10-09

TECHNICAL BULLETIN

Power Steering System – Revised Hose Clips on Reservoir-to-Pump Hose MODEL 1995-96 MY Sedan (4.0L) Range VIN 720001-776646

ILLUSTRATION 1

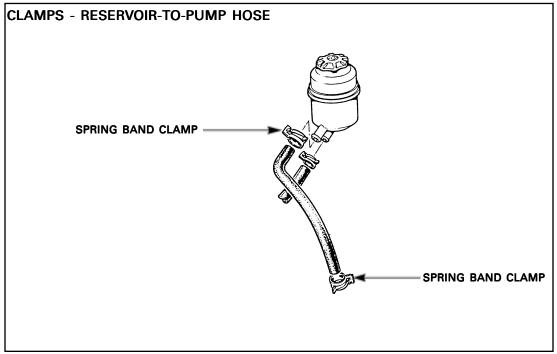
On 1996 MY 4.0L Sedan Range vehicles from VIN 776647, the specification of the hose clamps that retain the hose leading from the power steering reservoir to the power steering pump has been revised.

The spring band style clamp is now replaced by a worm drive clamp at each end of the hose (Illustration 1). This change provides an increase in clamping load, to overcome concerns of hose joint leaks, particularly at the connection to the pump.

Only in the case of a customer complaint of fluid leakage at either point on 1995-96 MY Sedan Range vehicles from VIN 720001-776646, replace the existing spring band clamp with a worm drive clamp (JHC 400401).

Torque the worm drive clamp to 3.5 Nm (31 lb. in.)
